ADDENDUM NO. 1

for CSP #250086

Org 208 Seagoville Elementary School – Addition and Renovation

Dallas Independent School District
April 27, 2026

01 PARTIAL ENLARGED DEMOLITION FLOOR PLAN - AREA B

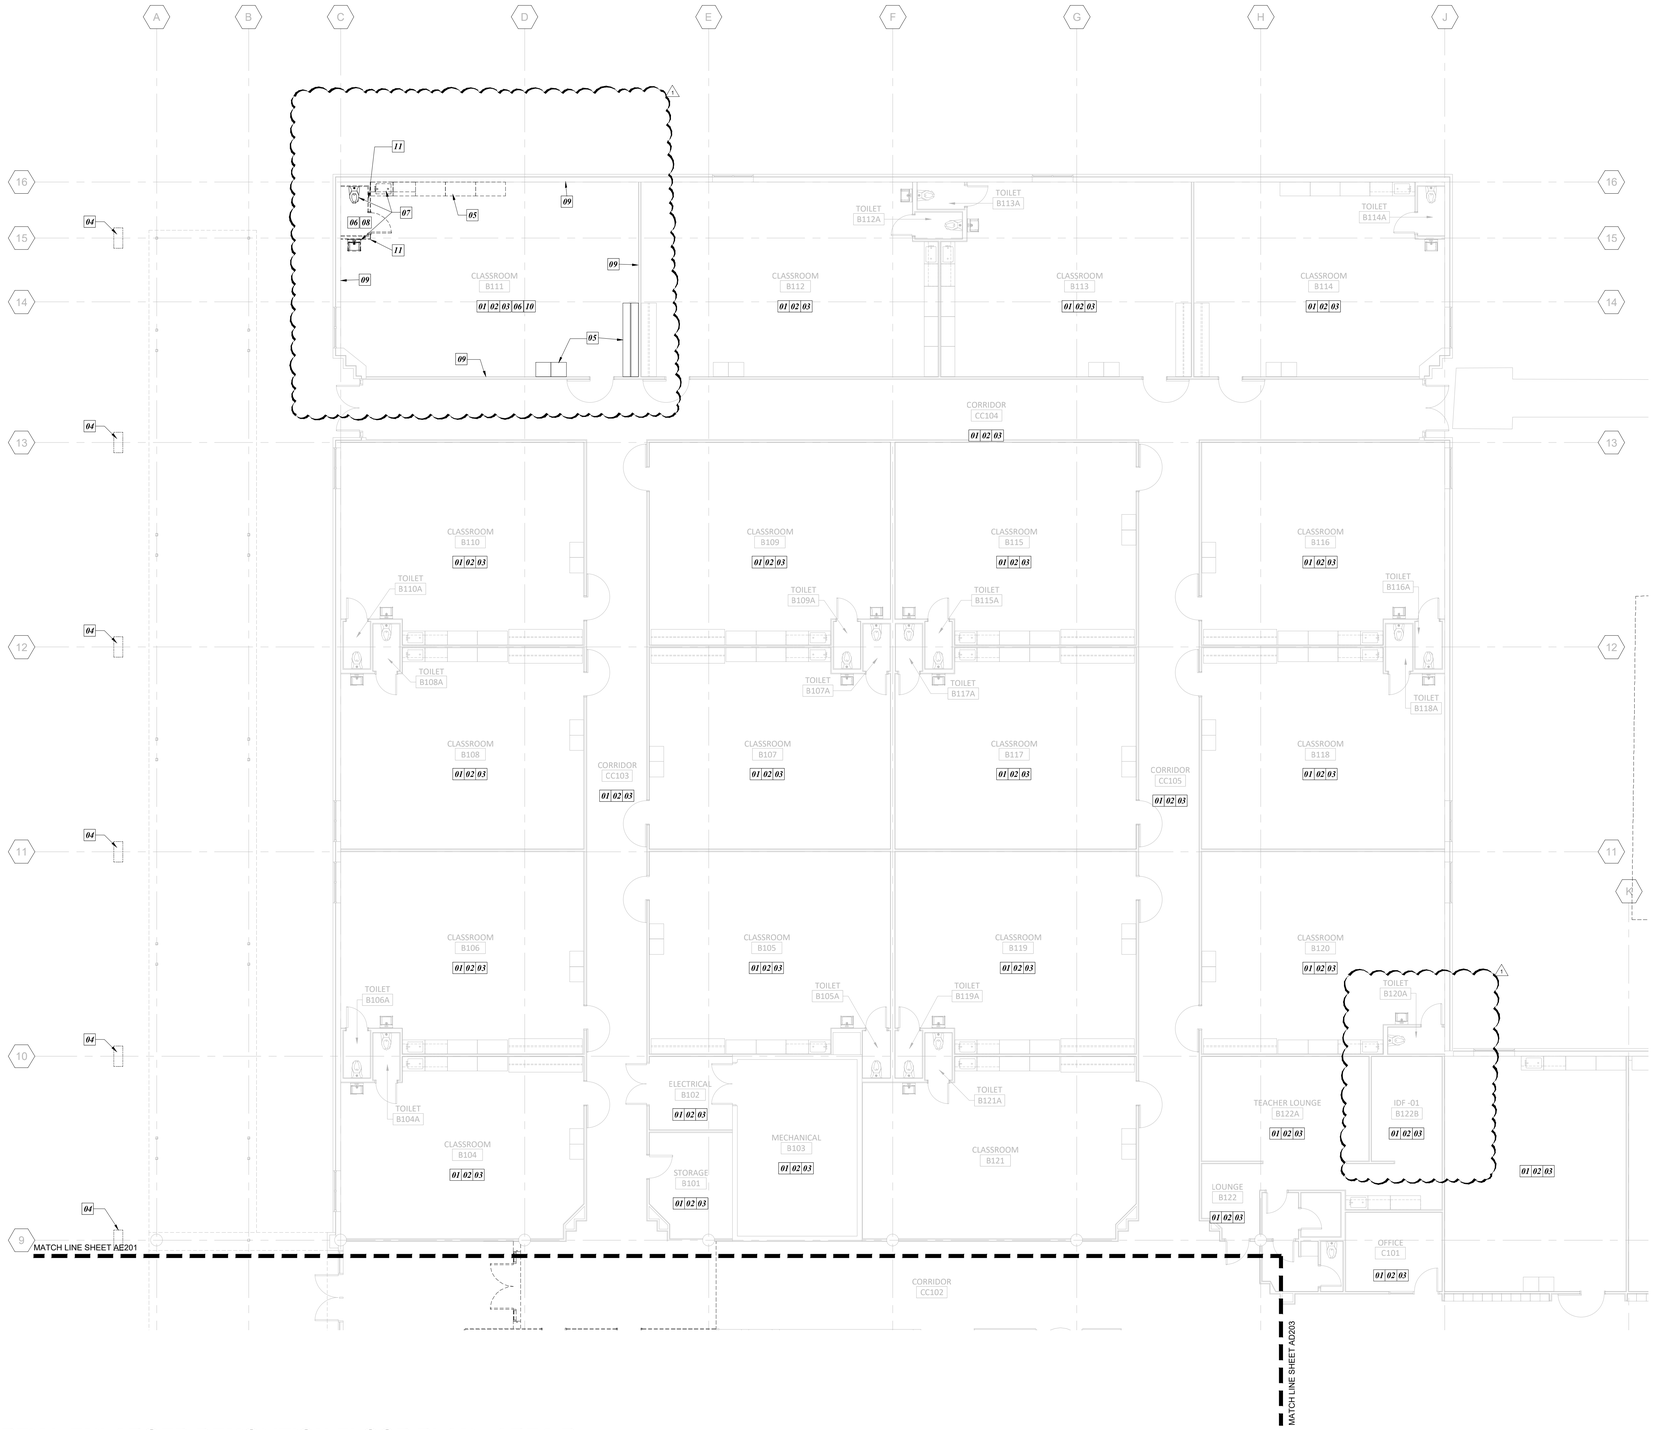
ITEM NO.12 AD202 - PARTIAL ENLARGED DEMOLITION FLOOR PLAN - AREA B

1. Removed annotation reference detail at classroom and IDF room.
2. Added General Notes and notes to classroom.

01 **PARTIAL ENLARGED ROOF PLAN - AREA D**

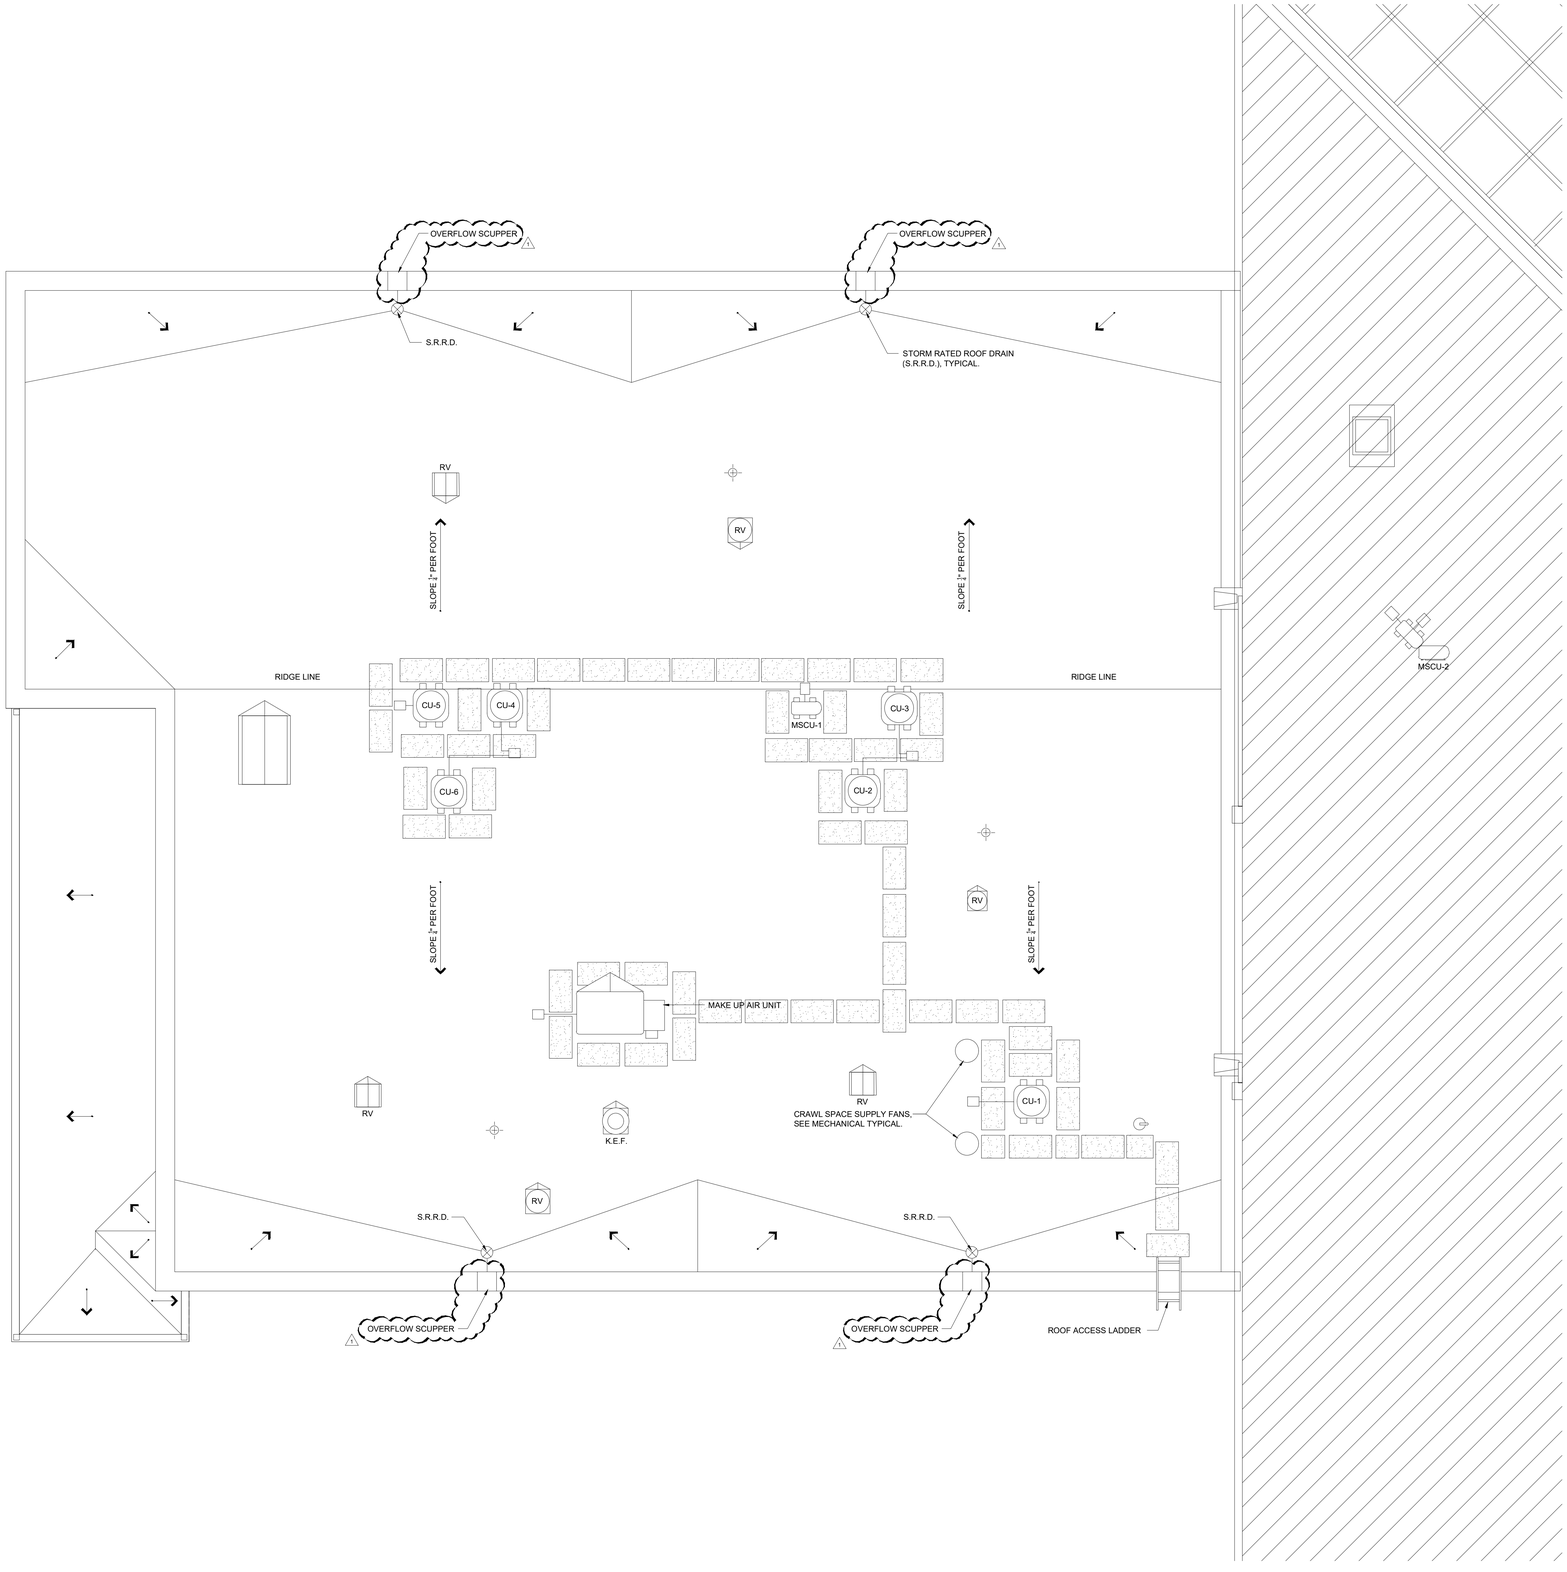
ITEM NO.15 AE206 - PARTIAL ENLARGED ROOF PLAN - AREA D

1. Removed overflow drain and added through wall overflow scupper.
2. Adjusted primary roof drain locations.

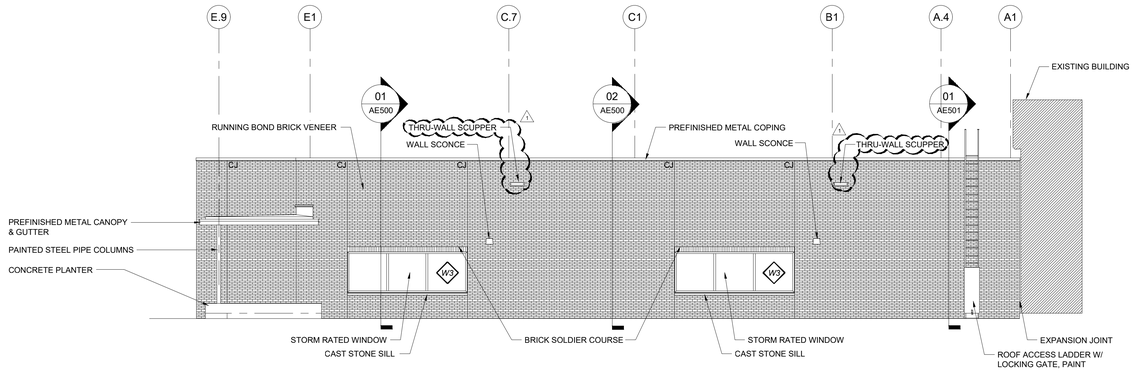
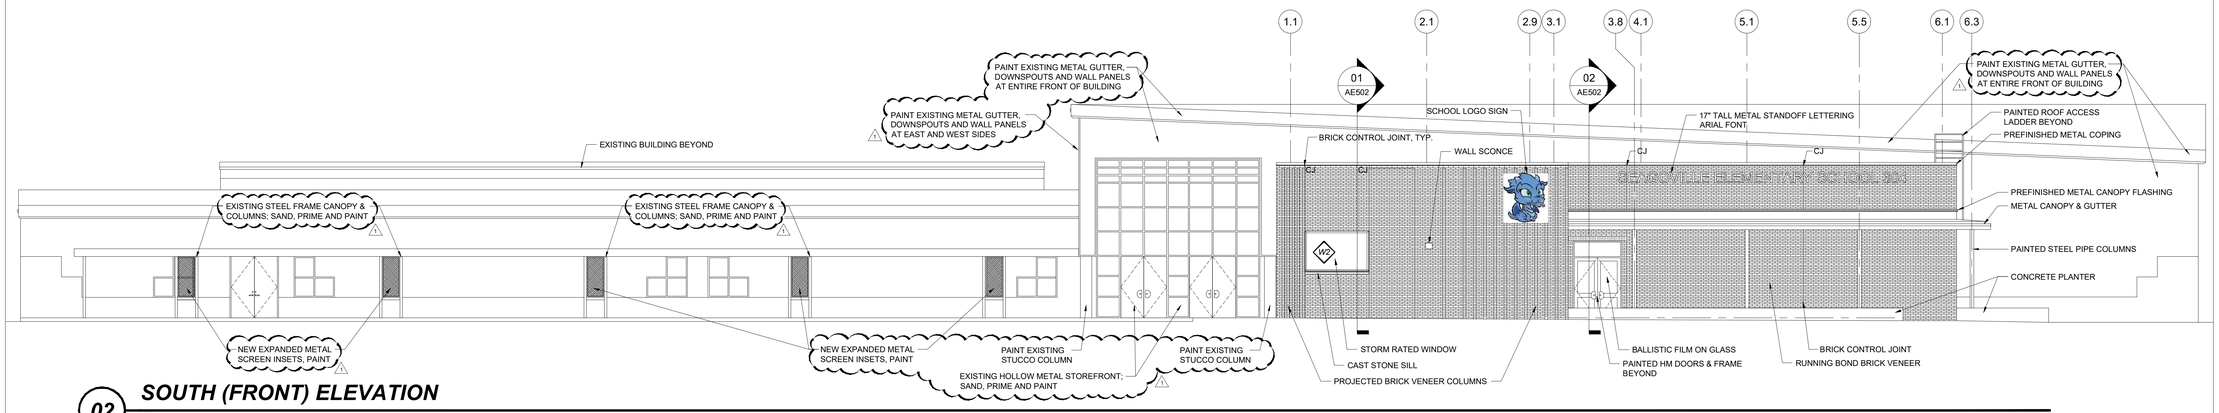
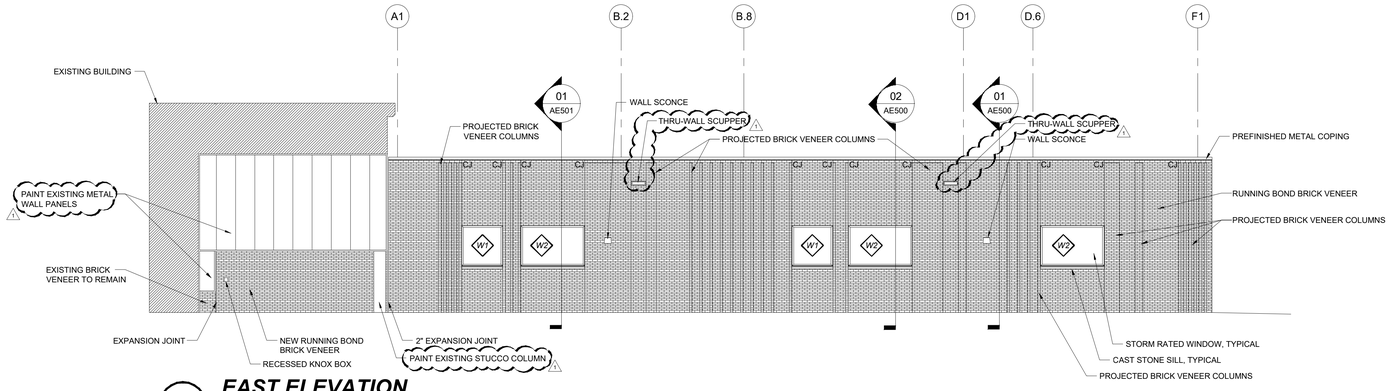
1. Updated exterior elevations with the through wall overflow scuppers
2. Added note to clarify expanded metal screen inserts for the existing canopy
3. Added noted to paint the existing canopy and the existing metal panels.

01 FOUNDATION PLAN - AREA D

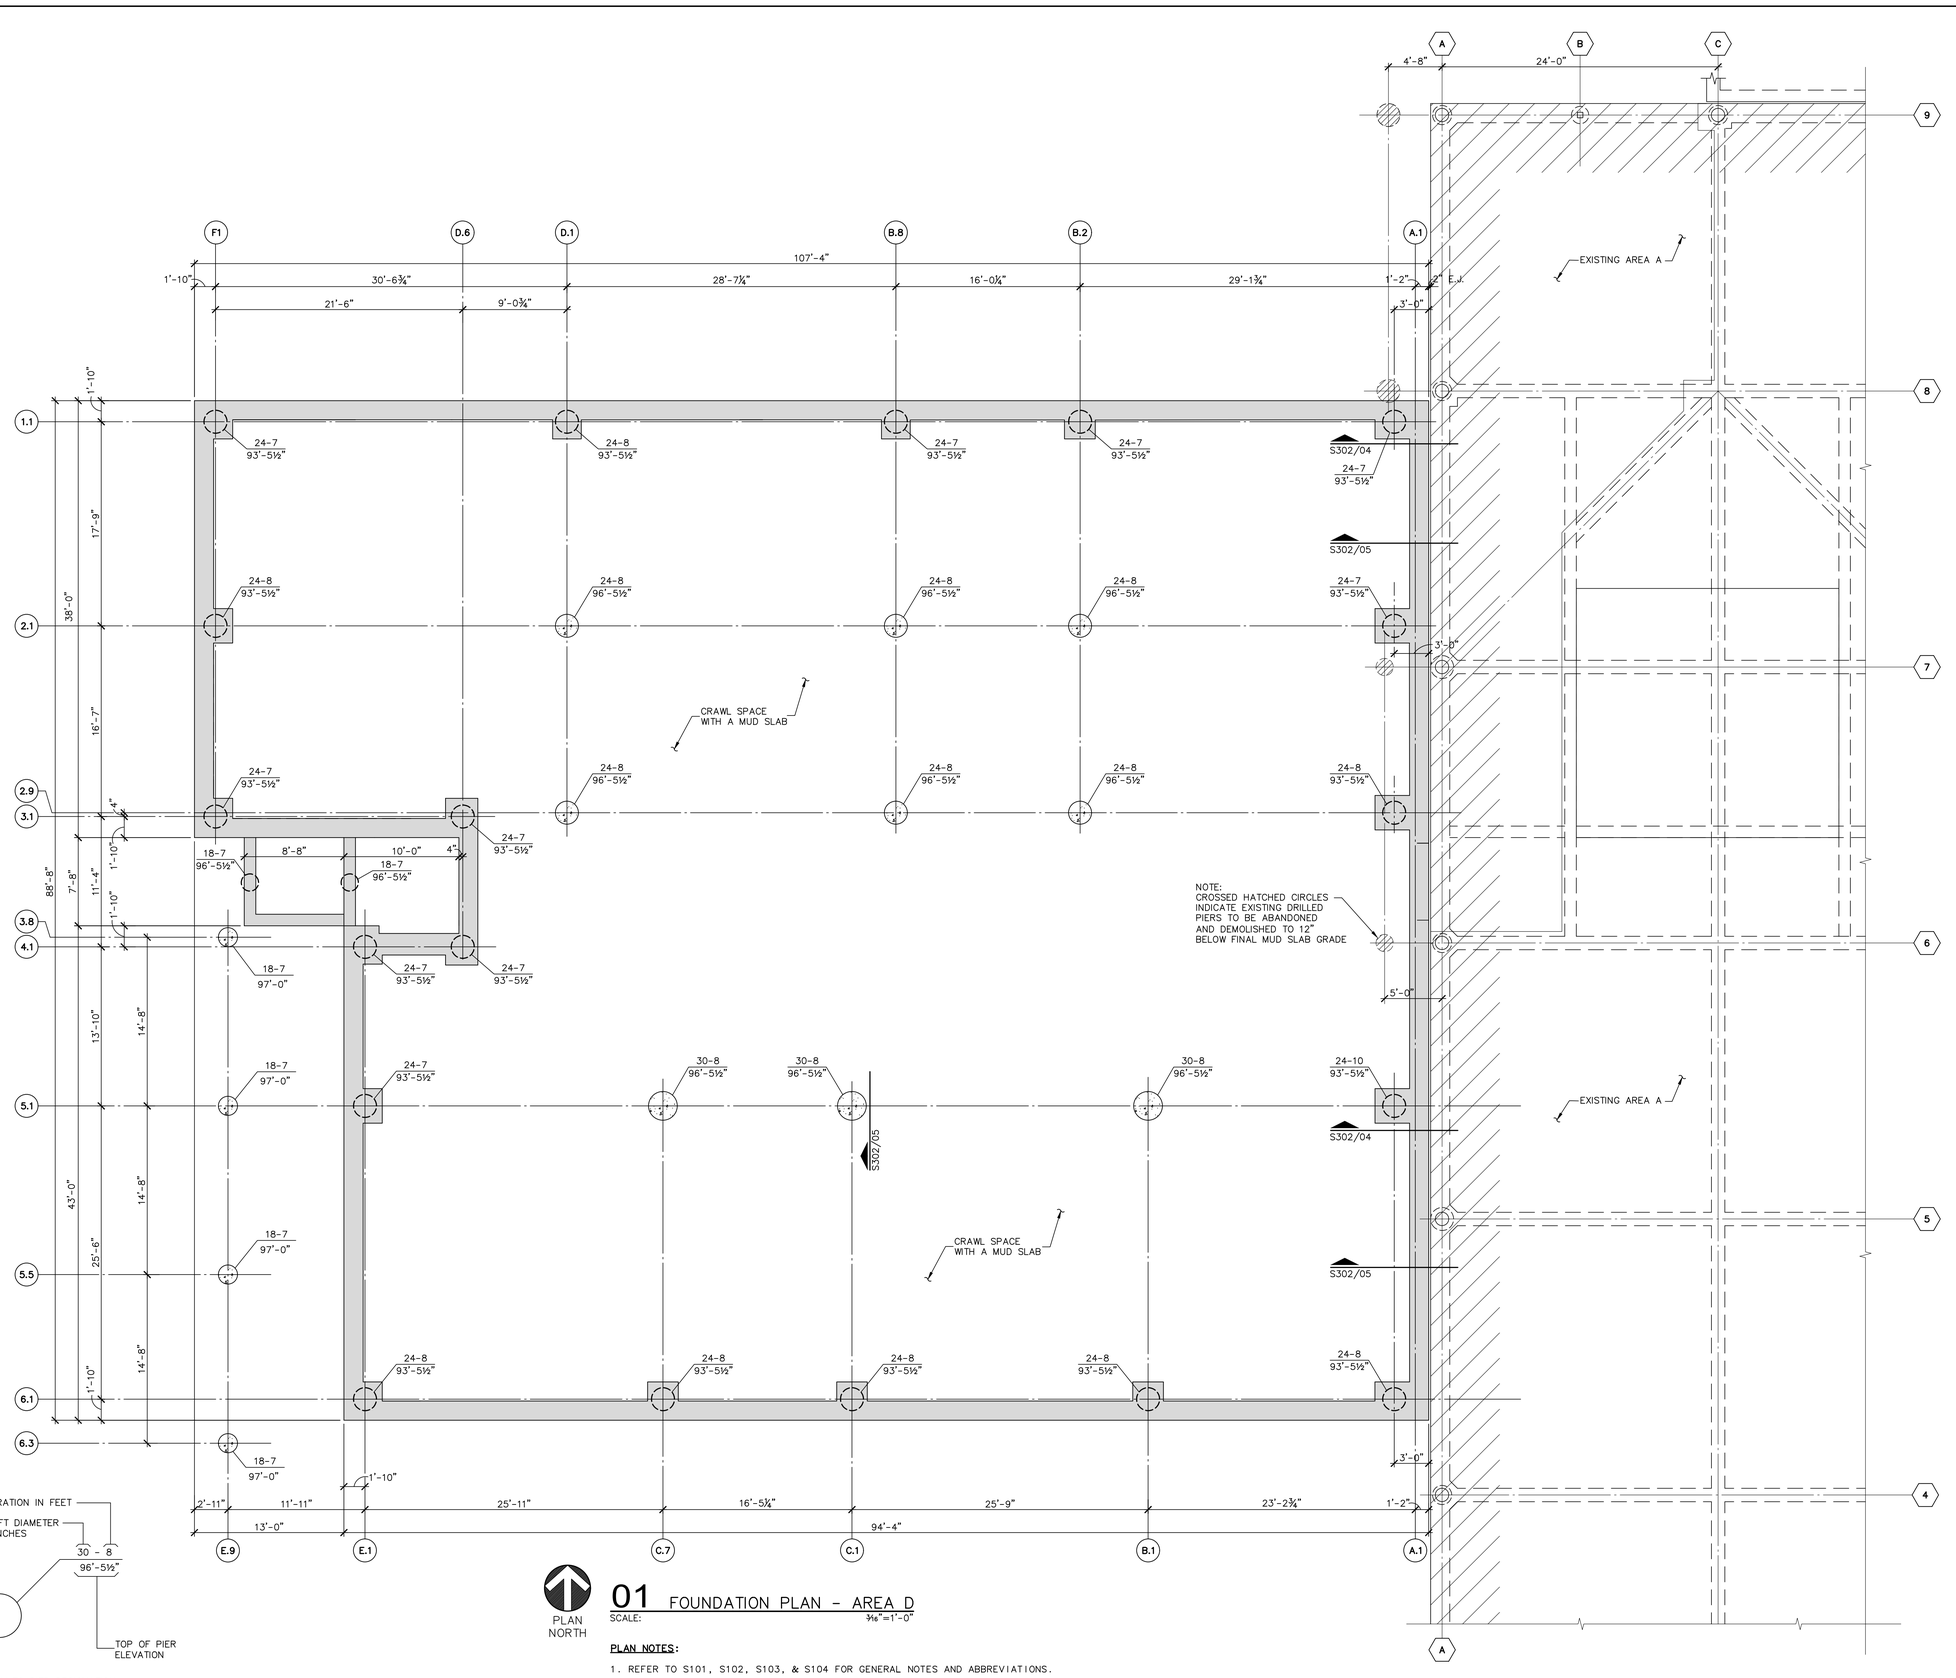
ITEM NO.31 S200 FOUNDATION PLAN AREA D

1. Updated entire foundation plan sheet.
